Water Management Plan – Dendrobium Mine

9.0	Update to template. Removal of references to IMC/South32. Inclusion of groundwater monitoring for surface facilities and new LDP. Reflected change in status for GDP from under construction to complete. Updated water balance data. Addressed comments from consultation.	12 November 2025

Appendix 2 outlines comments from the relevant government agencies following consultation and the ICHPL response.

Figure 1: Water Balance Summary – FY25 (volumes in ML)

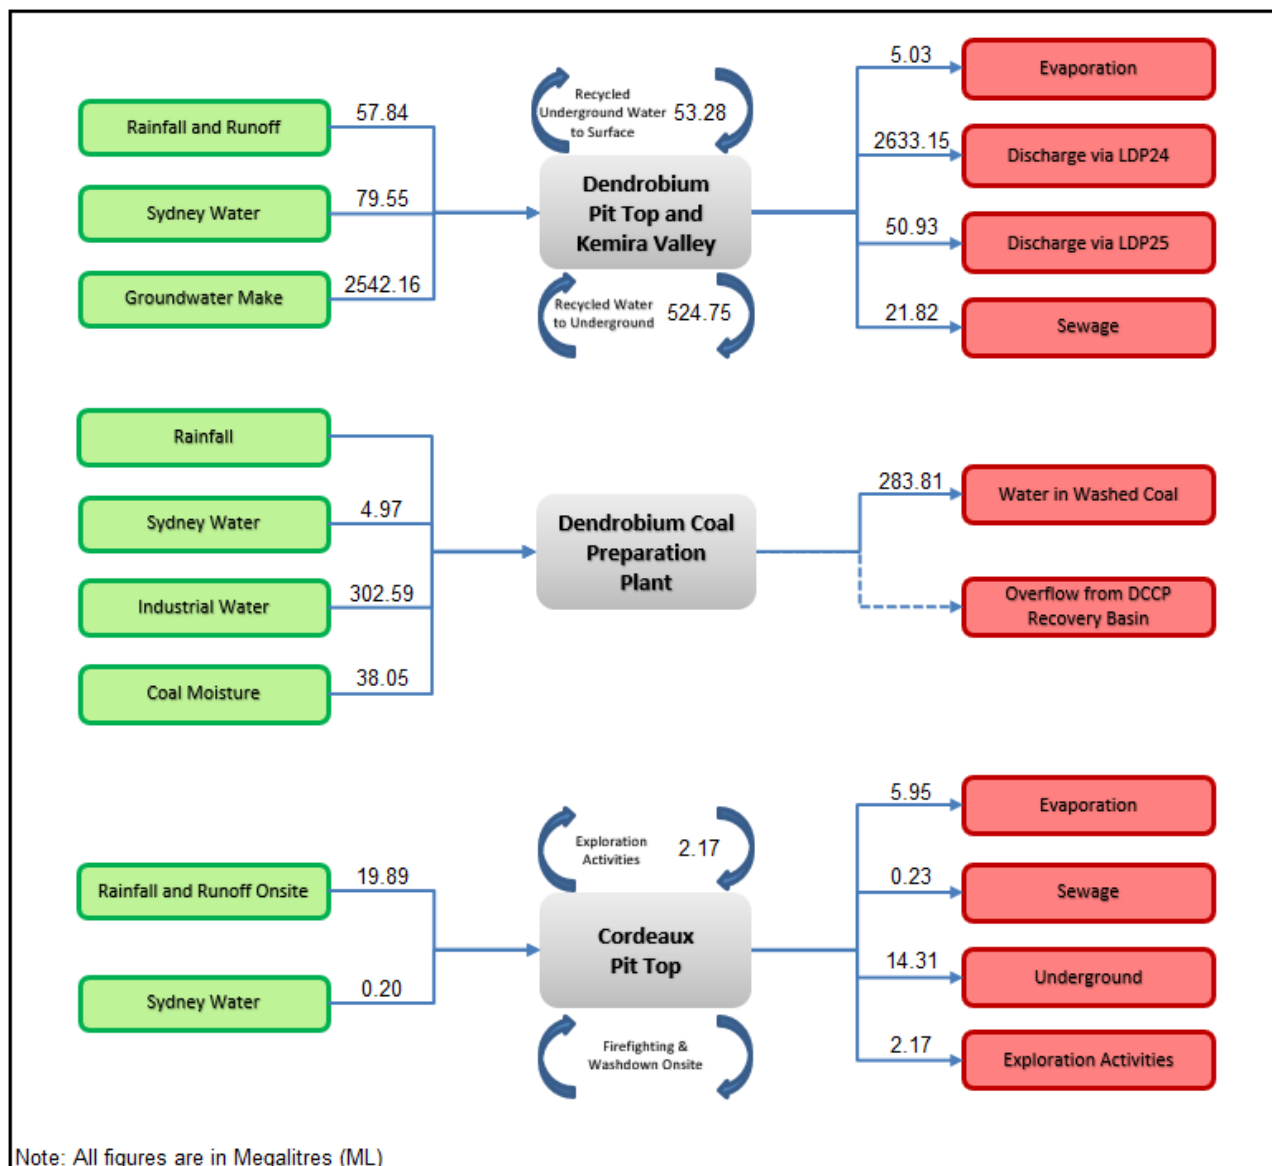
1.5 Recommendation prior to approval The proponent should clarify the annual site water balance reported for the Dendrobium Pit Top and Kemira Valley. <u>Explanation</u> The site water balance provided in Figure 1 of the WMP for financial year 2024 requires clarification for the Dendrobium Pit Top and Kemira Valley as there appears to be a discrepancy between the inputs and outputs in the order of 700 ML. The total annual inputs (rainfall and runoff, Sydney Water and groundwater make) equal 2639.85 ML, minus the net recycled water into the underground (322.86 ML) leaves a net volume of 2316.99 ML. However, the total annual outputs (evaporation, discharge via LOP 24 and LOP 25 and sewage) equals 3023.18 ML. There appears to be a discrepancy of an additional 706.19 ML which needs to be clarified and accounted for.	Figure 1 has been updated.

Plan 2: Water Balance Flow Charts

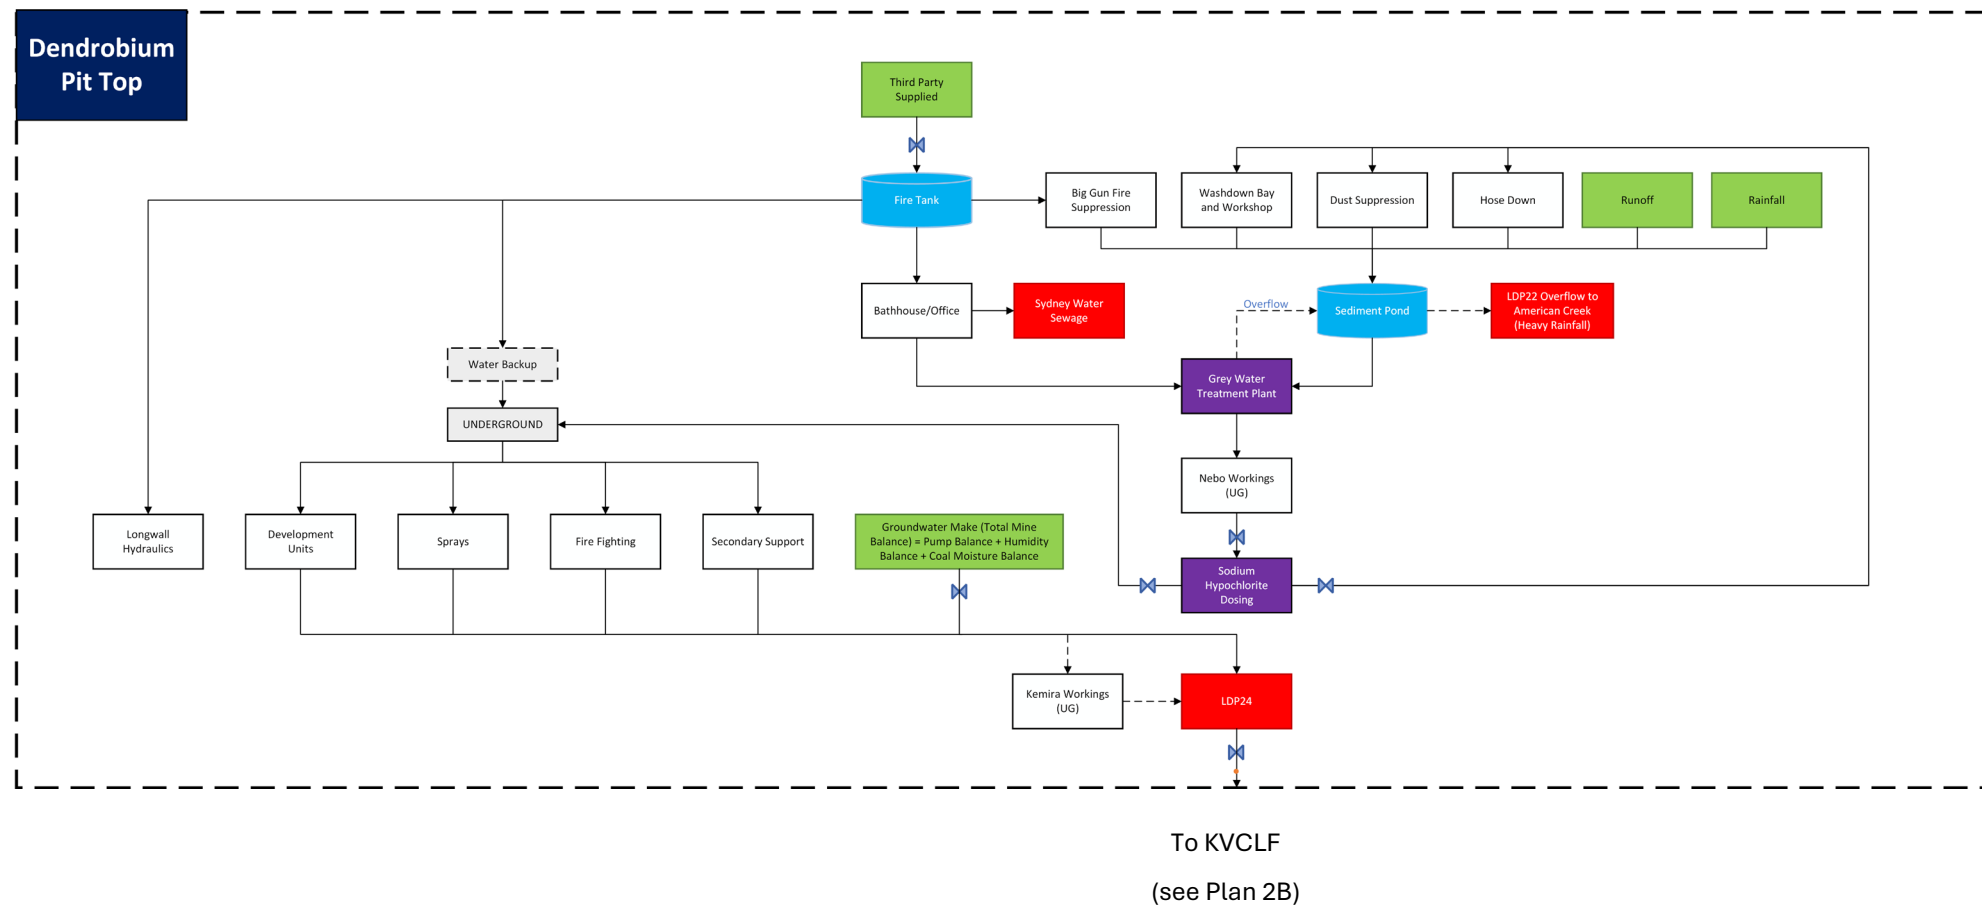
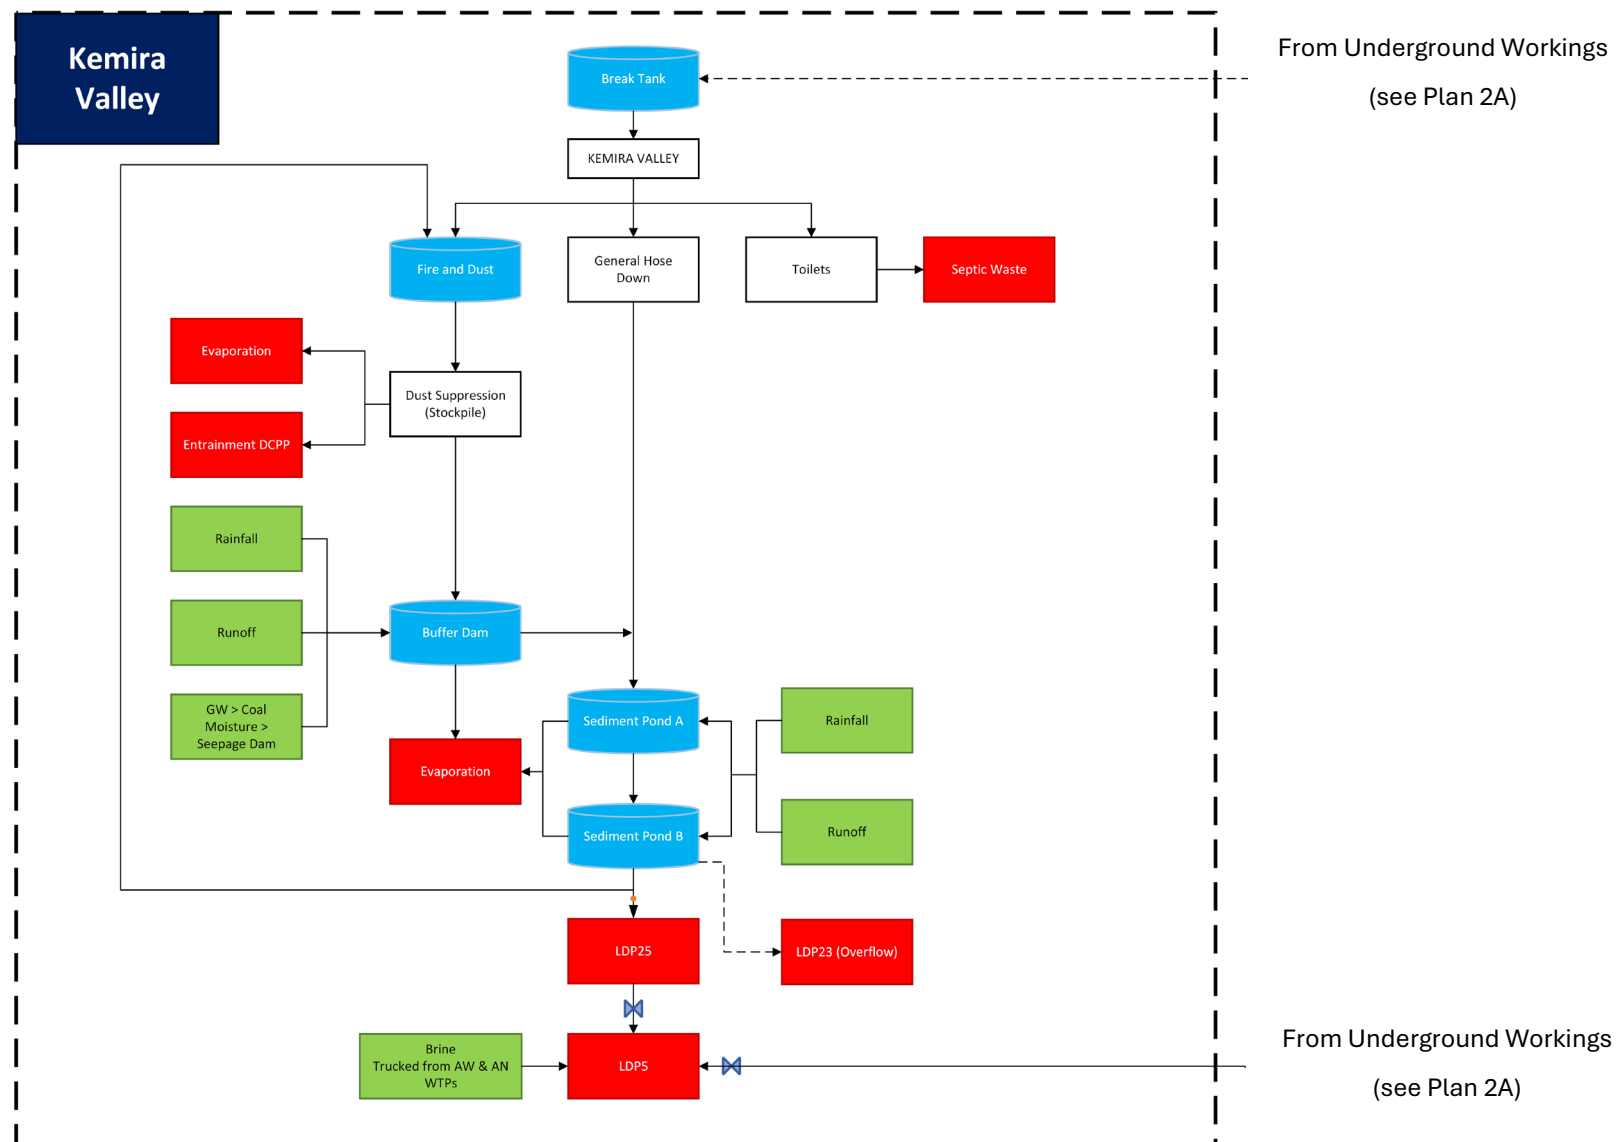
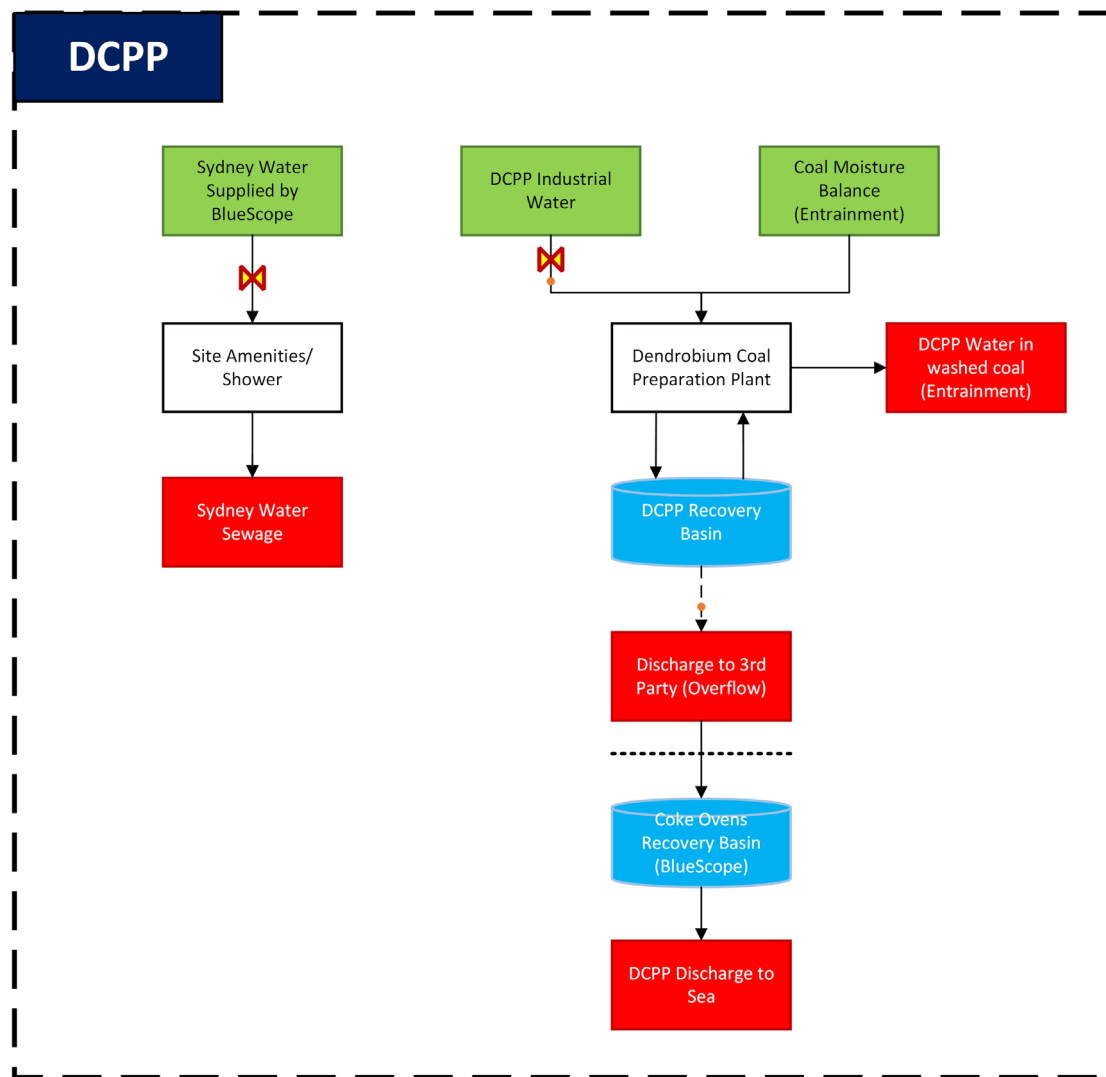
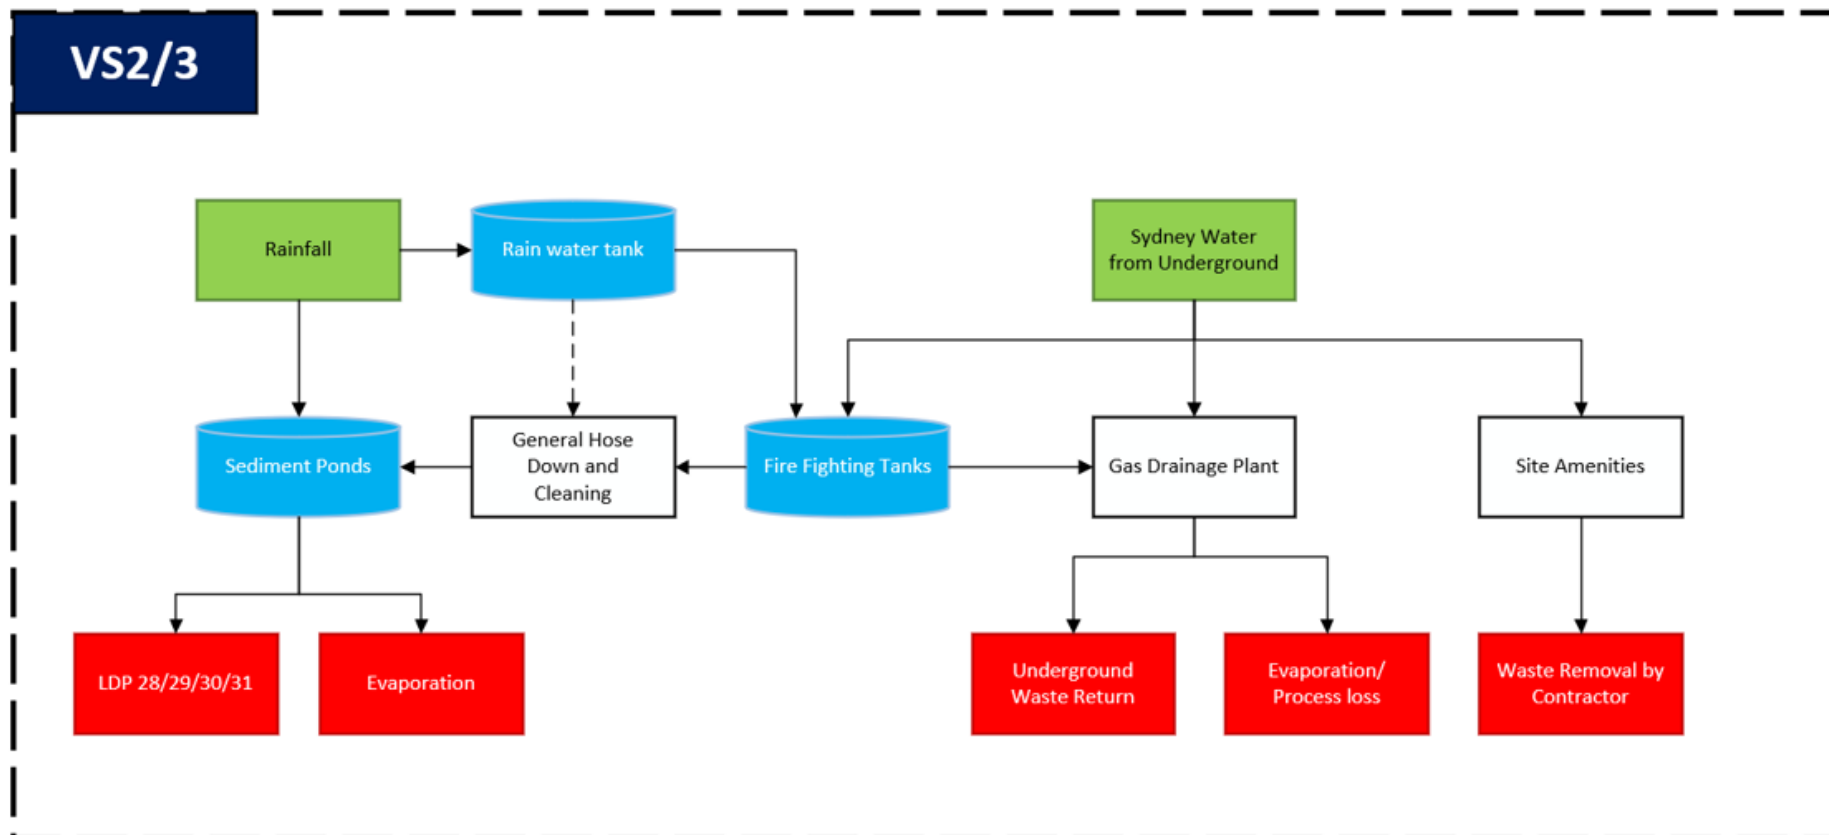
- It is recommended to use consistent water inputs and outputs presented in Figure 1 and water management schemes provided in Plan 2. For example, Cordeaux Pit top used about 8.1 ML last FY year where 97.5% was contributed by rainfall (and/or surface runoff) and 2.5 % was sourced from town water supply. However, water disposal summed up to 22 ML per year with about 72% disposed of into underground workings and 26% evaporated. Plan 2C for Cordeaux Colliery also refers to water use for exploration and offsite disposal. - Water use diagrams in Plan 2 and water balance in Figure 1 do not include information related to Ventilation Shafts 2/3. Consider updating Plan 2 and Figure 1 for completeness. - There are inconsistencies in naming of surface operations in the text and presented in water balance in Figure 1. It is recommended to align terminology for clarity (Cordeaux Colliery or Cordeaux Colliery Pit Top, or Cordeaux Pit Top).	Figure 1 and Plan 2E have been updated. Plan 2D has been included for VS2/3 to show the water inputs and outputs. These inputs and outputs are a subset of the Dendrobium Pit Top water balance. The naming has been updated to provide consistency.
